SUBJECT: **NEW VEHICLE DEMONSTRATION / DELIVERY HOLD**
Safety Recall 22S44 - Supplement #1
Certain 2021-2022 Model Year Bronco 4-door
Rear Door Child Safety Lock Inspection

New! REASON FOR THIS SUPPLEMENT

- *Labor Allowances: Labor time 22S44B has been increased to 1.2 hours.*

FIGURE 3

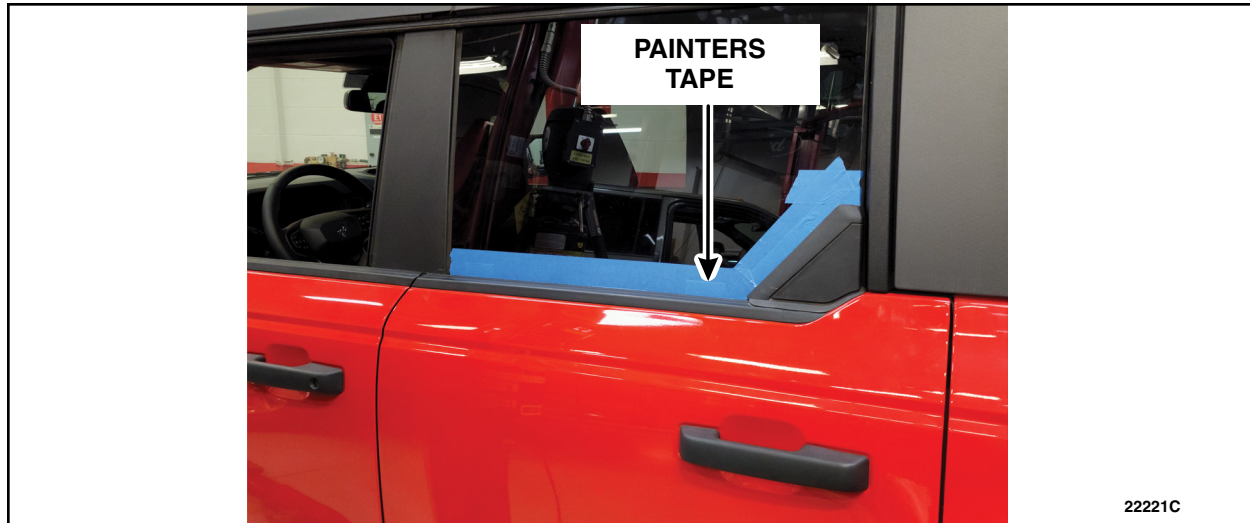
6. With the window rolled up and the door open, apply painters tape or equivalent to window glass, lining it up with the window seal. This will aid in re-installation of the glass. See Figure 3.

NOTE: BEFORE removing the fasteners, mark all of the fasteners for the rear door glass run and rear door window regulator with a paint pen or permanent marker.

NOTE: When reinstalling the window glass, align the tape with the window seal to ensure proper fit before tightening the fasteners. Door window glass adjustment is not necessary when following this procedure.

FIGURE 4

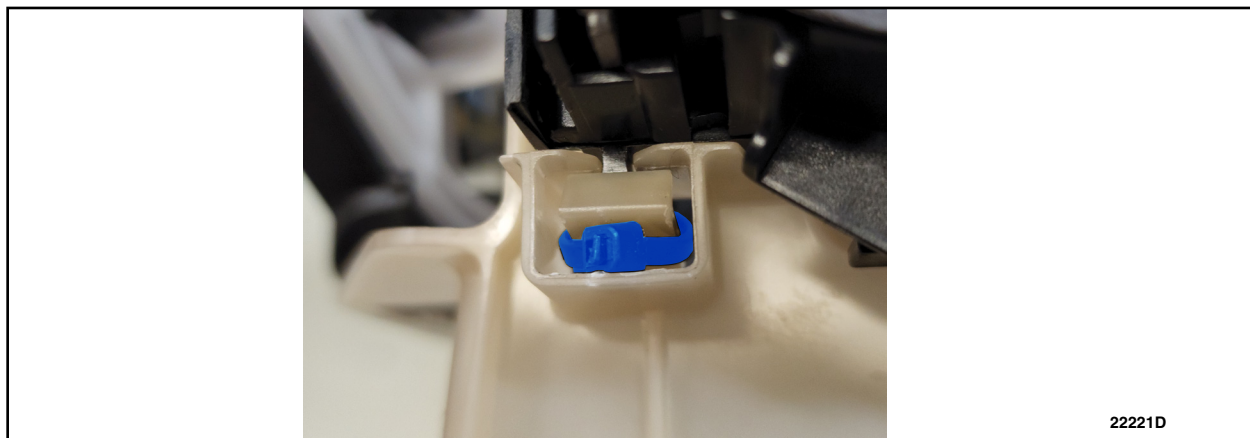
NOTE: If latch(es) are equipped with a zip tie, remove from assembly. Zip tie is to be replaced during reassembly. See Figure 4.
